## Application for Works Approval

**Works Approval Number** W6624/2021/1

**Applicant** BHP Nickel West Pty Ltd

**Premises** Kambalda Nickel Concentrator  
Durkin Road, KAMBALDA WA 6442

**Figure 2: Typical Section of Perimeter Embankment**

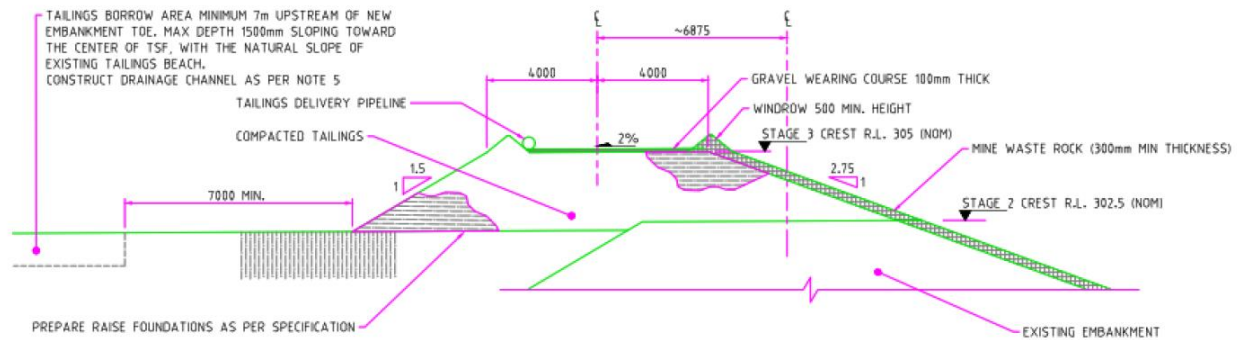
<b>Decision report</b>		
2.2.2 Proposed work, Perimeter Embankment, page 1	<p>Construction materials will also be sourced from other areas as outlined in the design report.</p> <p>The applicant requests an update of this section to include reference to other material sources.</p>	Amended

Figure 6: TSF 3 (NoI 373) depicting the type of soil where TSF 3 was built.

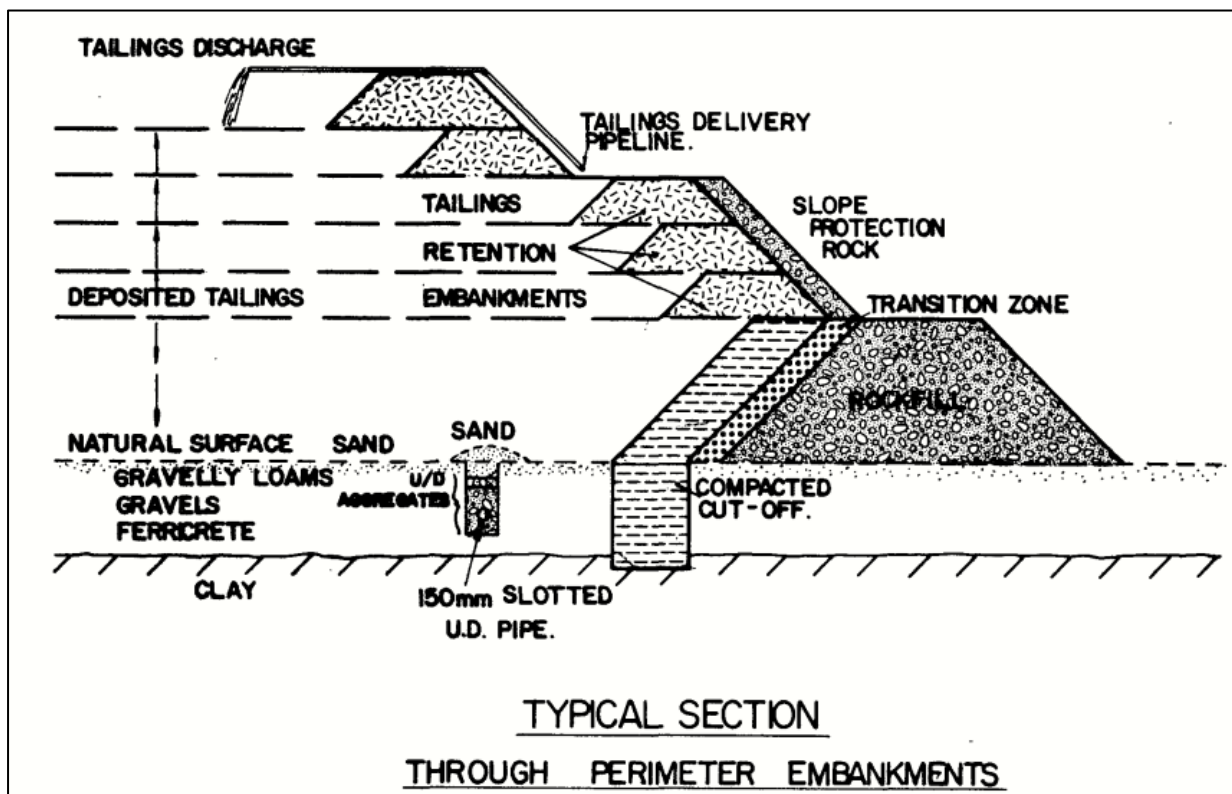
2.3.1 DMIRS Geotechnical review	<p>The figure included is for TSF3A, not TSF3B.</p> <p>Figure 6 in the OMS shows the relevant cross section for TSF3B. Design and construction details for TSF3B are outlined in the OMS in the paragraph above and below Figure 6.</p>	<p>Figure description amended. The purpose of Figure 5 is to show the soils where the foundations of TSF 3 were built, which are relevant to assess seepage.</p> <p>As stated in the text, the mining proposal for TSF 3 was for one cell that covered the area of TSF 3A and 3B.</p> <p>The legend in for the figure in the NOI 373 is: typical section through perimeter embankments Figure 2.</p>
